# Conceptual Review Agenda

# Pierce Subdivision Plat

**Re:** Pierce Subdivision - Plat

**Description of project:** This is a request to subdivide the parcel located on the northeast corner of Cherry Street and Lyons Street (parcel #9710102048), across from the Putnam School. The parcel would be subdivided into six single-family lots with the easterly tract to be used as stormwater detention. A portion of the parcel is in the City floodway. The site is located in the Low Density Mixed-Use Neighborhood (L-M-N) zone district. This proposal will be subject to Administrative (Type I) review.

CONCEPTUAL SITE PLAN

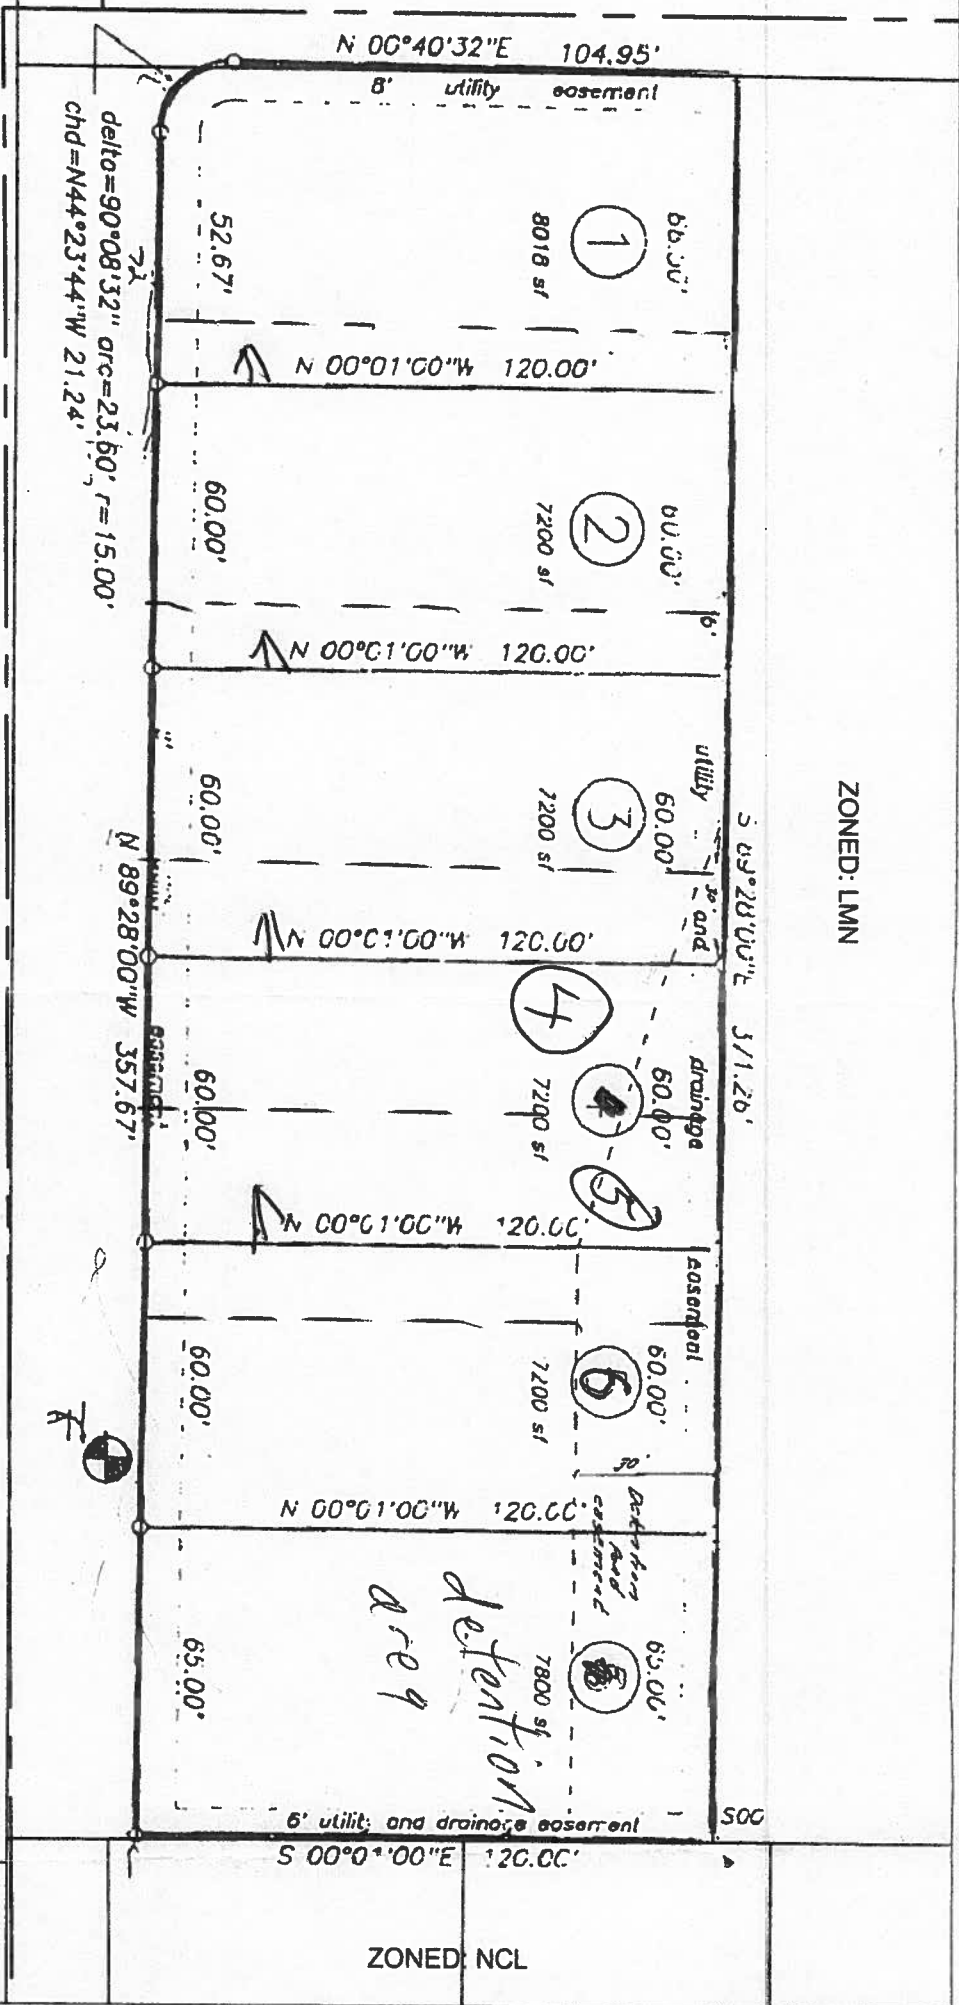
1. This property is zoned LMN (Low Density mixed-use neighborhood) which requires 4-9 dwelling units per acre. It looks like you are meeting this requirement with 5 units.
2. The setbacks for LMN are:
  - Front 15'
  - Rear 8'
  - Side 5'
  - Corner Side 15'
3. The residential building standards found in 3.5.2 will apply.

2. There appear to be six ¾-inch water service stubs and six sewer service stubs into the site from the mains in Cherry. These service stubs will need to be reused or abandoned at the main with any development project for the site.
3. The water conservation standards for landscape and irrigation will apply. Information on these requirements can be found at: <http://www.fcgov.com/standards>
4. Development fees and water rights will be due at building permit.

1. The anticipated change in traffic volume is not expected to rise to the threshold of needing a TIS. Based on section 4.2.3.D of LCUASS, the Traffic Impact Study requirement can be waived.
2. Adjacent street road improvements (Cherry and Lyons) including sidewalk will be needed.

1. 1. A portion of this project is located in a City regulatory 100-year Floodway and High Risk Flood Fringe in the West Vine Basin, and must comply with the safety regulations of Chapter 10 of City Code. A Flood Risk Map will be provided to the applicant at Monday's meeting.

2. 2. New residential structures may not be built in the floodway.
3. 3. Nonstructural development (fill, driveways, sidewalks, vegetation, etc.) can be completed within the floodway as long it can be proven that the work will not cause a change in the Base Flood Elevation (BFE), or a change to the boundaries of the floodway or flood fringe (No-Rise Certification). An alternative to acquiring a No-Rise Certification would be to perform a map revision to the floodplain. Either of these options must be performed, and signed, by a Professional Engineer registered in the State of Colorado, using floodplain modeling and technical analysis consistent with current floodplain modeling guidelines and standards.

14. Onsite detention is required for the runoff volume difference between the 100 year developed inflow rate and the 2 year historic release rate. The development team will need to investigate an appropriate outfall from the site.

Required fire access for the site appears to be met with the subdivision of the six lots. Code language provided below.

5. This project is responsible for dedicating any right-of-way and easements that are necessary for this project. Additional right-of-way will be required along Cherry Street to accommodate the parkway and detached sidewalk that is to be constructed by this project along the frontage. Additional right-of-way may be needed along Lyons Street to accommodate the parkway and detached sidewalk that is to be constructed by this project along the projects frontage. This shall include the standard utility easements that are to be provided behind the right-of-way (9 foot along Cherry Street and Lyons Street).

3. Along Cherry Street, street-facing garages must be recessed behind the front line of the house by four feet. Garages must be setback from the back of the sidewalk by no less than 20 feet. For Lot One, the garage may be accessed from Lyons Street and, since this would be the side of the house, the garage would not have to be recessed, but still must be at least 20 feet behind the back of the sidewalk.
4. The garage doors must not comprise more than 50% of the ground floor, street-facing linear building frontage. For Lot One, if the garage is accessed from Lyons Street, this standard does not apply.
5. Has any consideration been given to locating the garages on rear portions of the lot with access gained by a single lane driveway that flares out at the garage? This would allow the house to have a greater width. And, with southern exposure, such an arrangement would

6. Has any consideration been given to sharing a driveway between two adjoining lots? This arrangement was done successfully at the Bennett Street Bungalows on Bennet Street. Again, such an arrangement allows for a wider house that would otherwise be possible with each lot having its own two-car wide driveway.

12. A Landscape Plan will be required. Street trees must be located in the parkway along both streets and spaced at intervals that do not exceed 40 feet. The parkway should be a minimum of six feet for tree growth. Street trees must be a minimum of two-inches in caliper and selected from the official list provided by the City Forester. While street trees must be kept 40 feet from street lights, Ornamental Trees may be placed to within 15 feet of a streetlight. A street tree will also be required along Cherry Street in front of the stormwater detention pond. It appears that nine trees are required along Cherry and three along Lyons.

13. It appears that the H.O.A. would own and maintain both the stormwater detention pond and the water quality features that are required to meet the requirements for Low Impact Development. The water quality feature will need to include plants that provide for both conveyance and treatment. The pond will have to be landscaped as well. Staff can work with the applicant on a landscape design that includes low water trees, shrubs, and ground cover. Please be aware that irrigation will be required for all plants to be properly established. Please contact the Water Utility about the process of obtaining a separate water tap that is used for irrigation only.
